**Commercial Final Development Plan
Re-Submittal Routing Sheet**

Application Number: PL2015158

Application Type: Commercial Final Development Plan

Application Name: The Summit

SHEET No.
E1
PARTIAL FLOOR NORTH
POWER & LIGHTING PLAN
OF 3

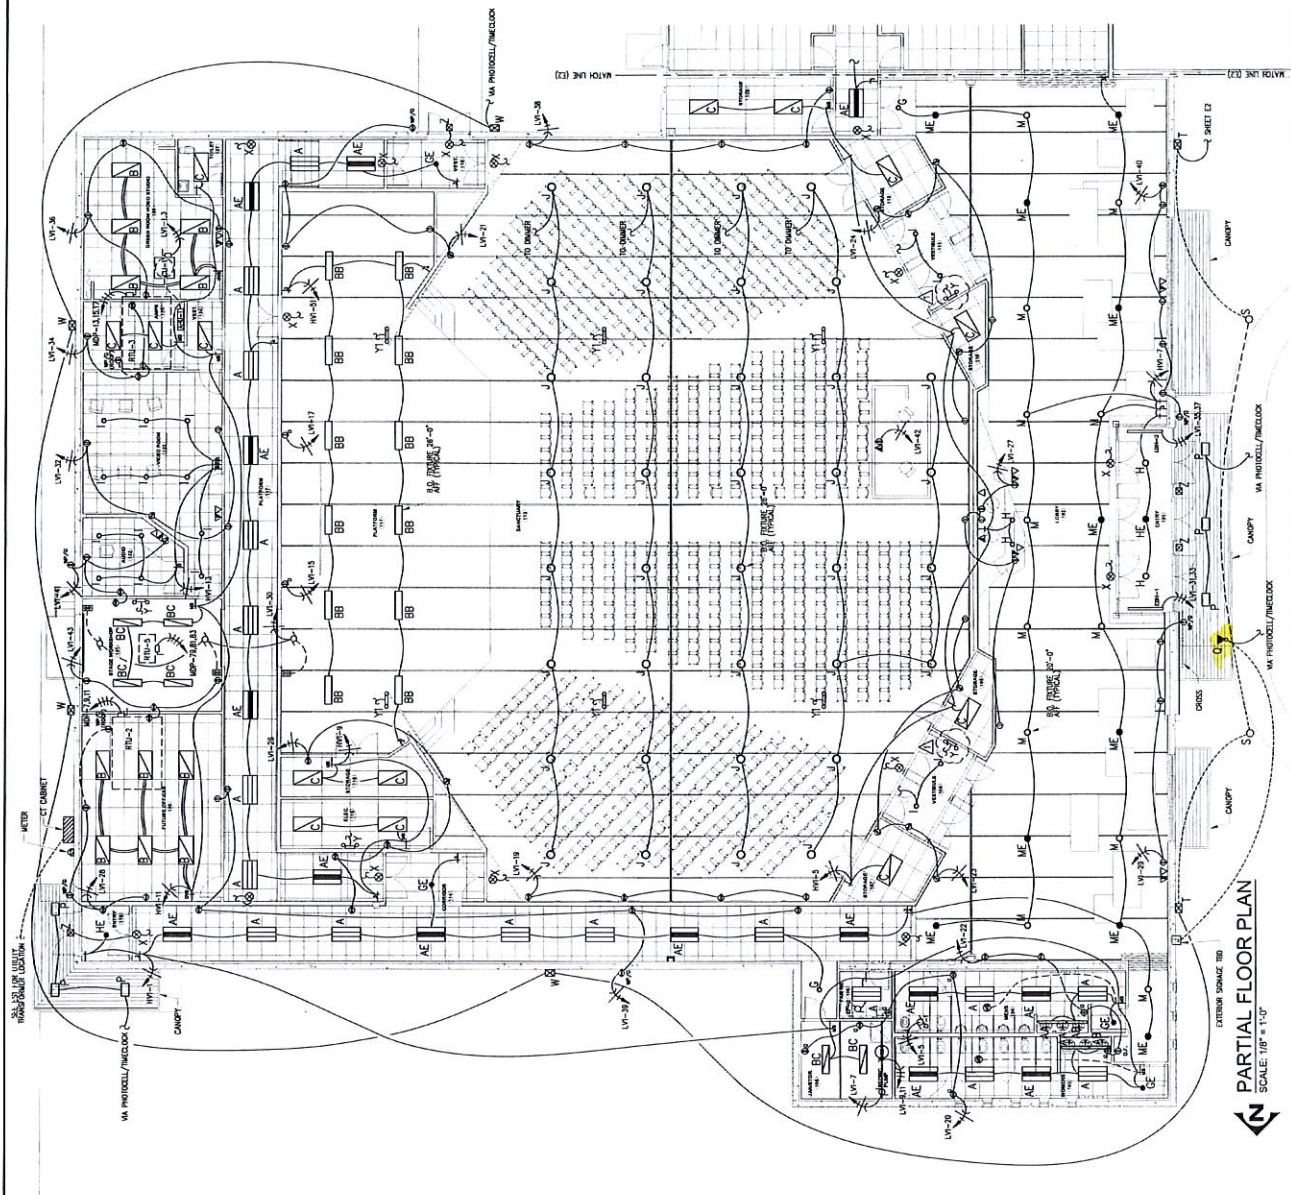
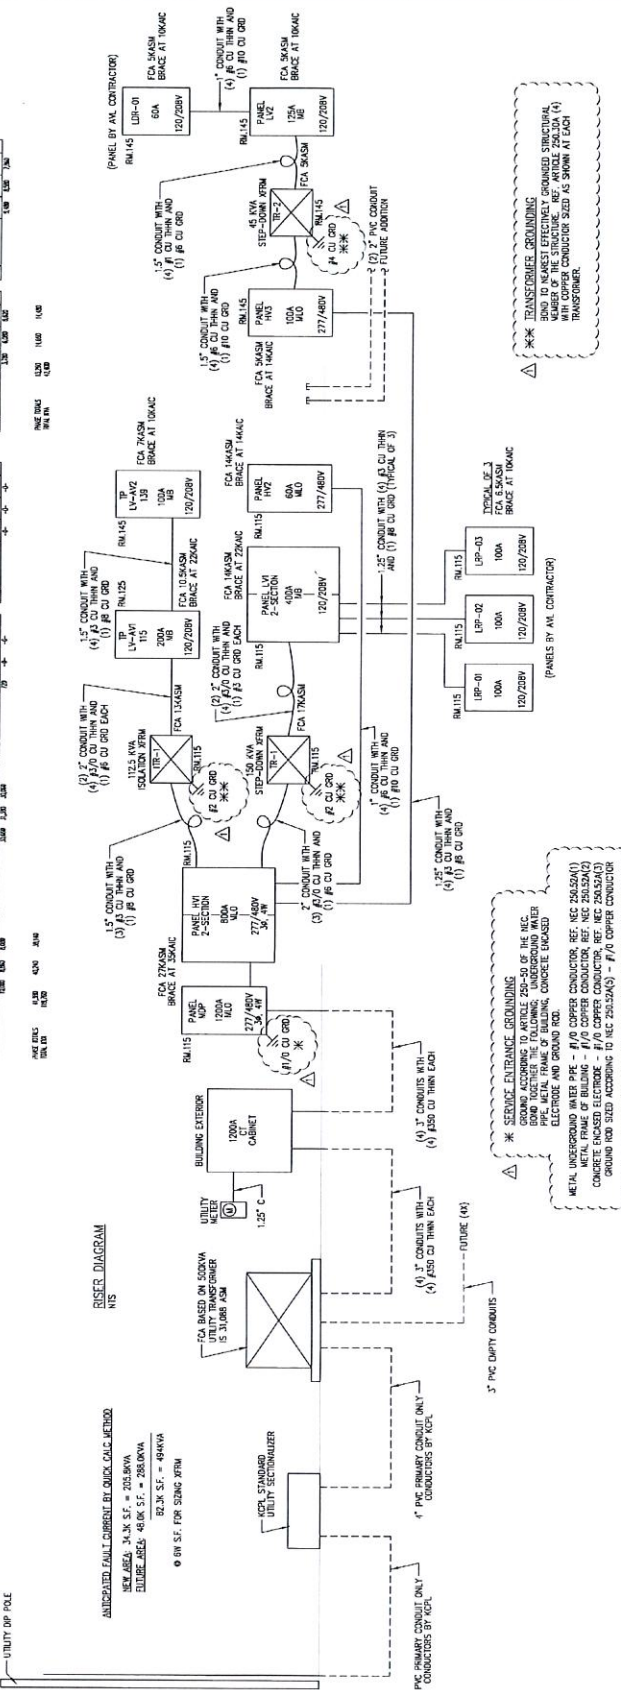
Ron,
Attached are full-size signed and sealed E1 and E2 sheets. Let me know if you need anything else.

SHEET No.
A0.10
SITE DETAILS

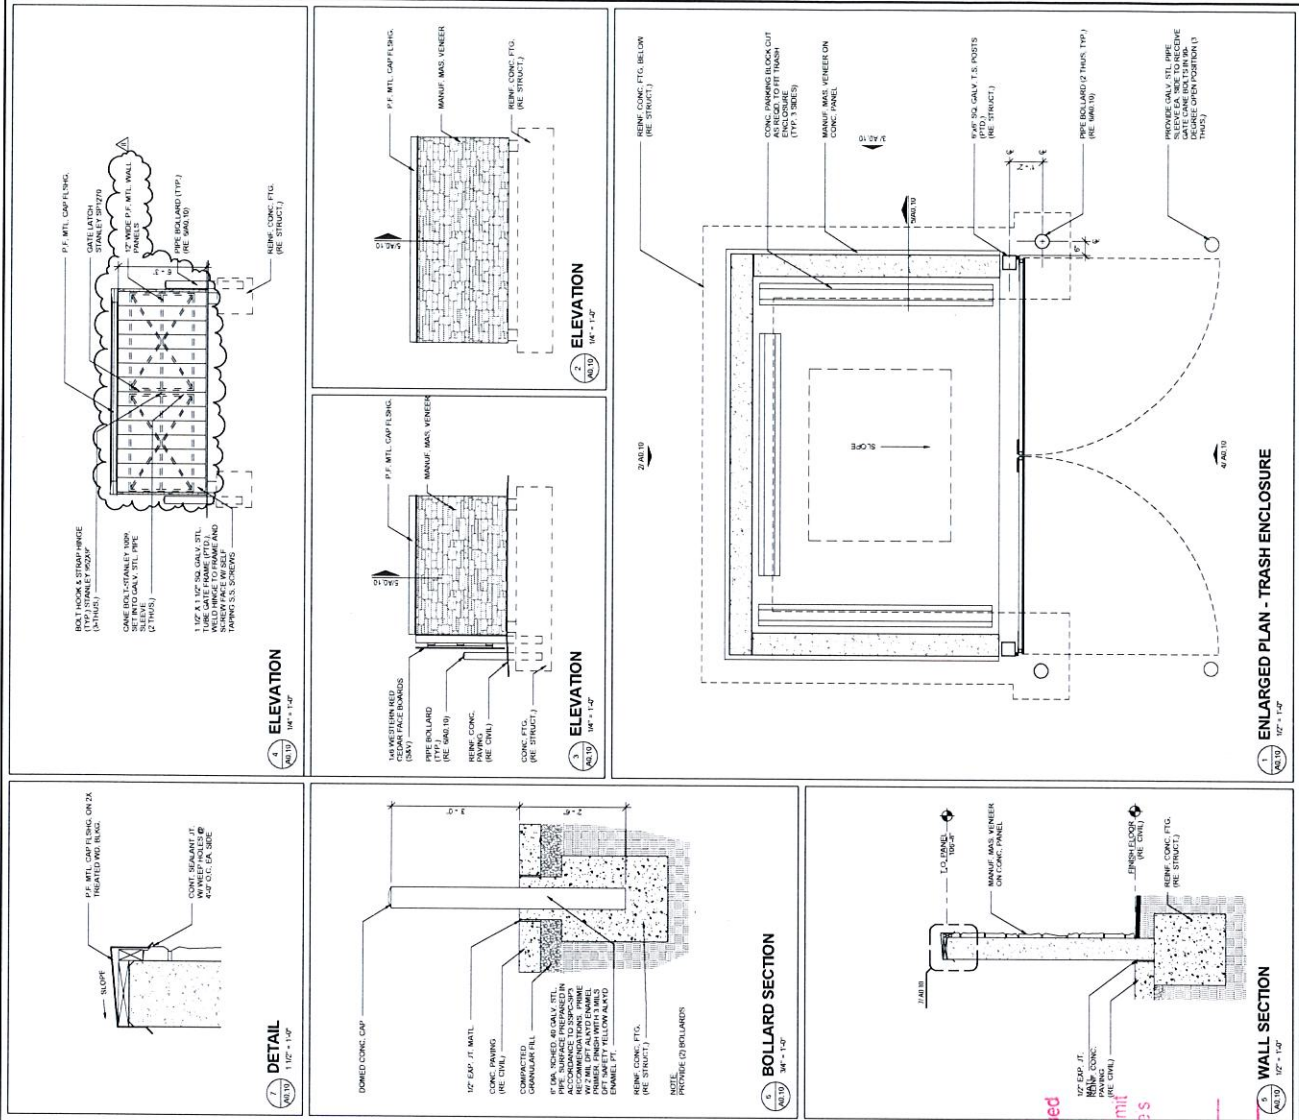
9. Provide details for parking lot pole light pedestals/bases. Per UDO requirements, concrete pedestals/bases shall not exceed three (3) feet in height and shall be included in the maximum overall height.

Pole light base detail - page 30
